MANDATORY SERVICE BULLETIN**NUMBER:** SB11-11**REVISION:** 00**DATE:** Oct 20, 2011**SUBJECT:** BATTERY BOX REWORK**EFFECTIVITY:**

The accompanying Field Service Instruction provides guidance for modifying the Kodiak 100 battery box to increase fatigue life. Contact Quest Customer Service for Service Kit P/N FSI-023.

FIELD SERVICE INSTRUCTION

TITLE: Battery Box Rework
SERIAL RANGE: Refer to Applicability Section, Page 1
JASC CODE: 5345

Figure 3-1: Drill-Down for Fastener Removal

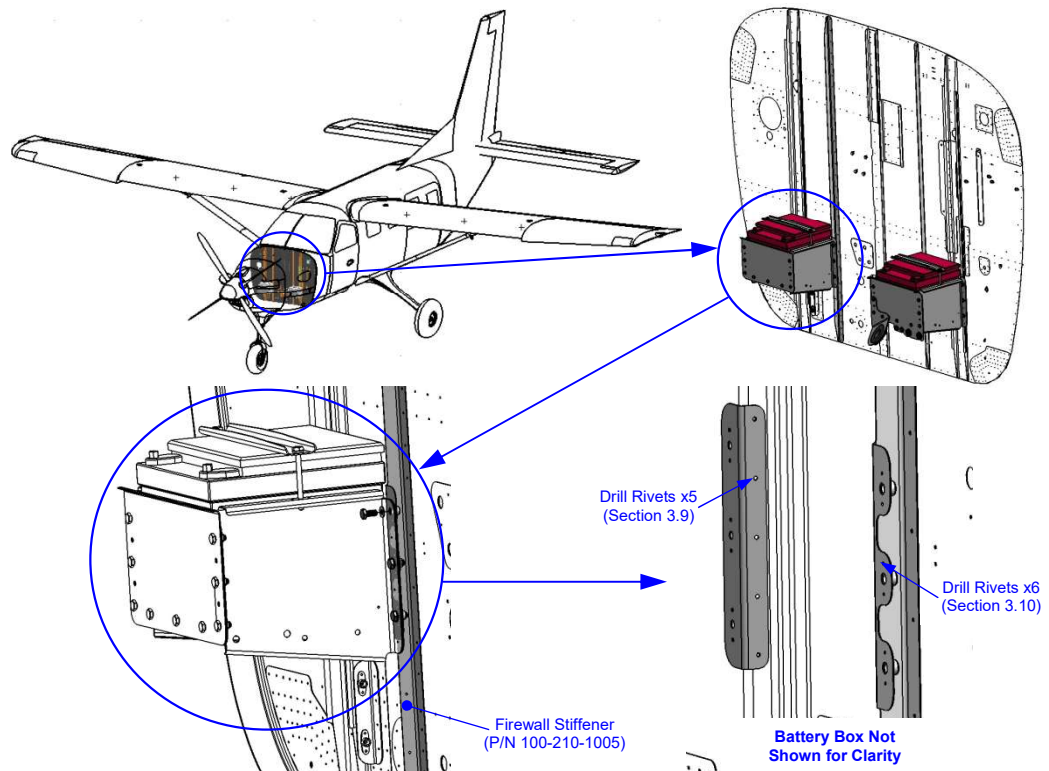
Drill out the five (5) fasteners securing each of the aluminum battery box mounting brackets (P/N 100-210-1027) to the firewall; refer to **Figure 3-1**. Remove and discard the mounting brackets.

Drill out the two (2) fasteners securing each nut plate to the stainless steel firewall stiffener; refer to **Figure 3-1**. Remove and discard the nut plates.

Figure 4-1: Battery Box Bracket Installation

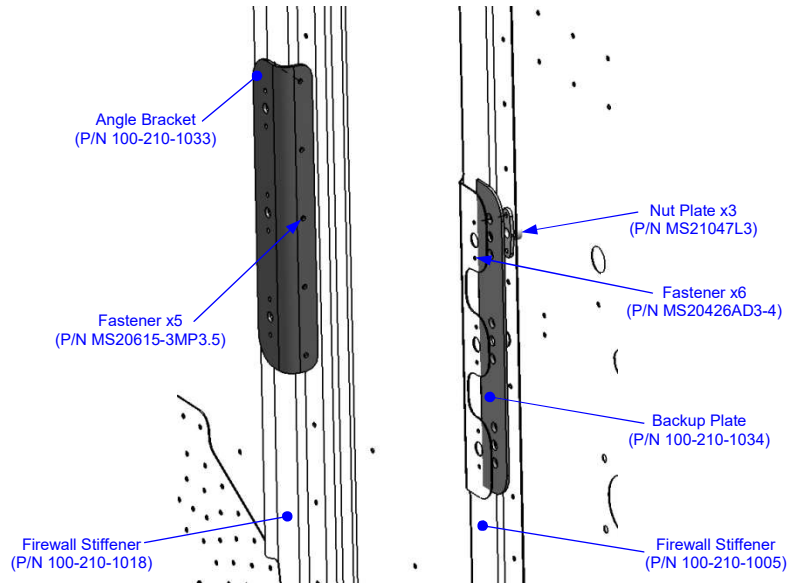
Position and secure the backup plate (P/N 100-210-1034) and three (3) nut plates (P/N MS21047L3) using six (6) MS20426AD3-4 fasteners; refer to **Figure 4-1**. This installation is mirrored on the opposite side of the aircraft.

Position and secure the aluminum angle bracket (P/N **100-210-1033**) using five (5) **MS20615-3MP3.5** fasteners; refer to **Figure 4-1**. This installation is mirrored on the opposite side of the aircraft.

Figure 4-2: Backplate Installation

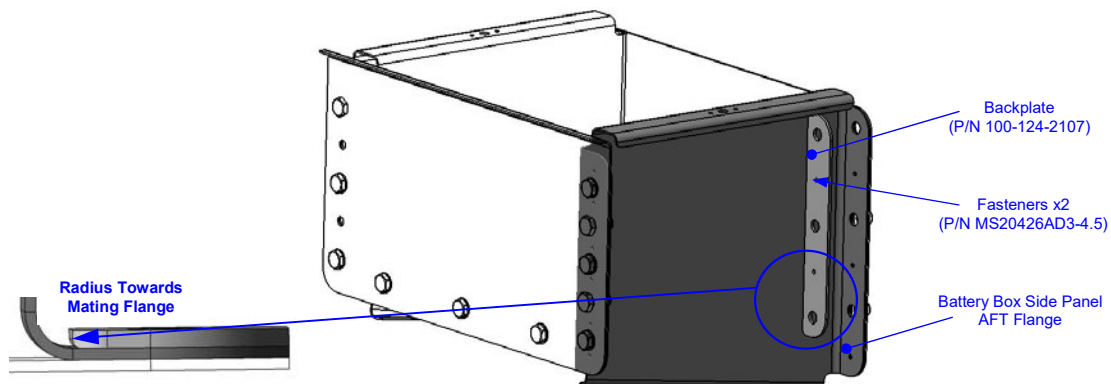
Position the backplate (P/N **100-124-2107**), ensuring that the radius on the backplate is facing toward the mating flange. Secure using two (2) **MS20426AD3-4.5** fasteners; refer to **Figure 4-2**. This installation is mirrored on the opposite side of the aircraft.
